# ***DLPC910, DLPR910A - Advised Continuous Row Command Operation***

## **ABSTRACT**

**Figure 1. DLPC910 Row Operation (Current)**

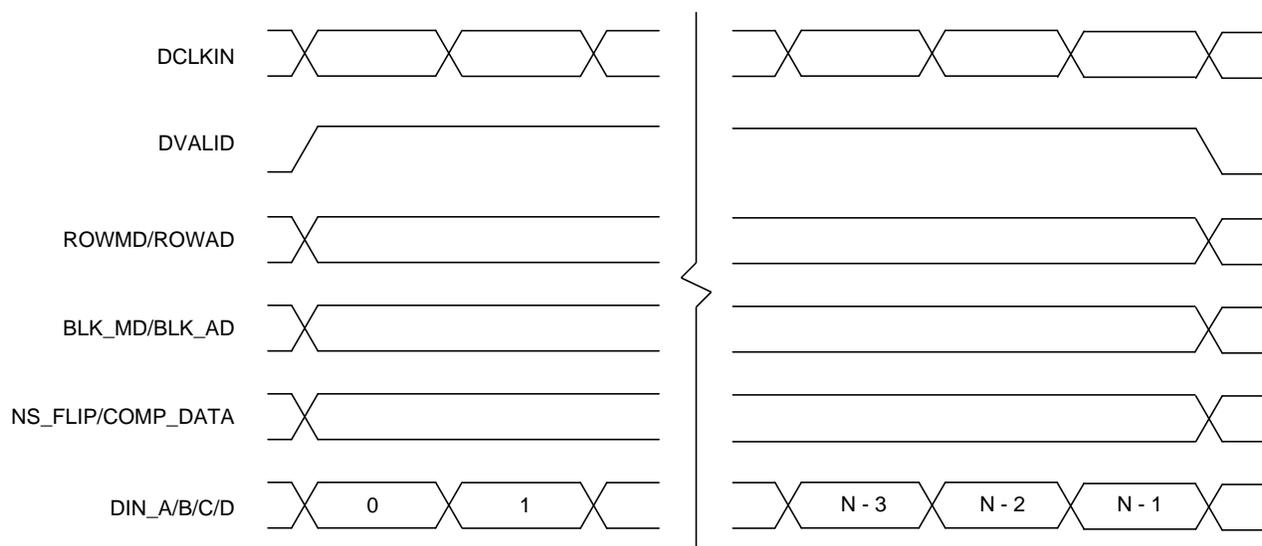
If the DLPC910 controller is configured using the DLPR910A PROM, when row cycles are sent continuously (no clocks between row cycles) while DVALID is held HIGH continuously, data will be incorrectly sent to the DMD. This includes No-Op row cycles.

A consequence of these modifications is a change to the method of sending row commands continuously.

Figure 1 shows the current timing diagram for DVALID during a row cycle:

**Figure 2. DLPC910 Row Operation (New Implementation)**

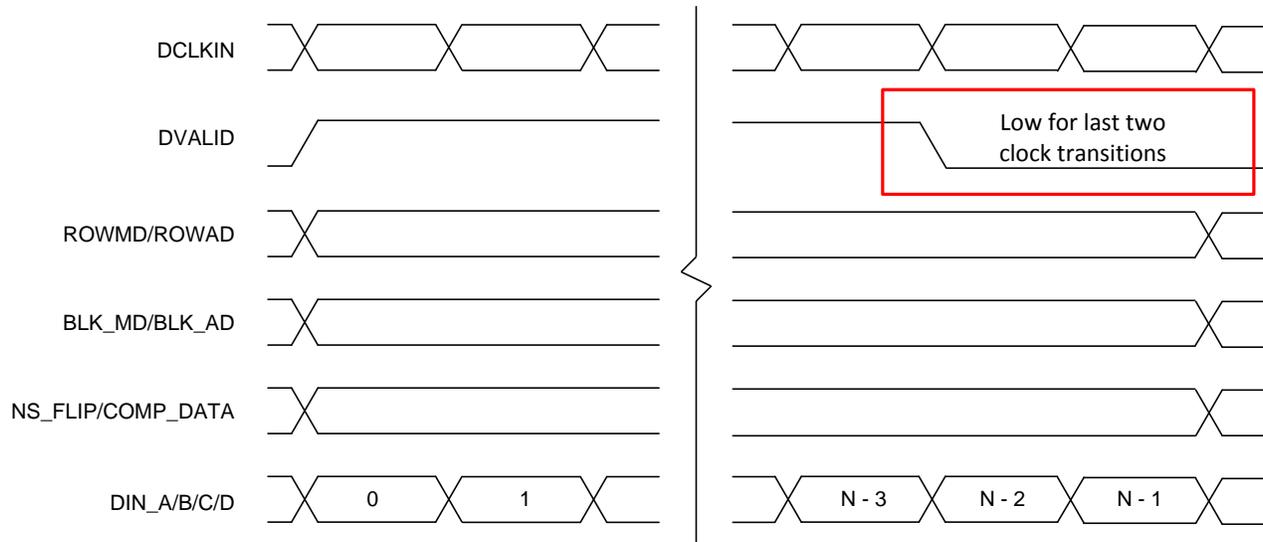
TI recommends implementing the solution shown in Figure 2 for all row cycle commands when using the DLPC910 controller configured with the DLPR910A PROM:

This implementation requires setting DVALID to LOW for the last two clock transitions (last clock cycle) of each row cycle, which will ensure that the row cycle commands and data are correctly sent to the DMD. This is for all row cycle operations including No-Op row cycles.

**NOTE:** Setting DVALID to LOW for the last clock cycle does not affect data read in the last two clock transitions. The firmware will finish the correct number of DIN\_(A/B/C/D) reads for the specific DMD started by the rising edge of DVALID at the beginning of the row cycle.
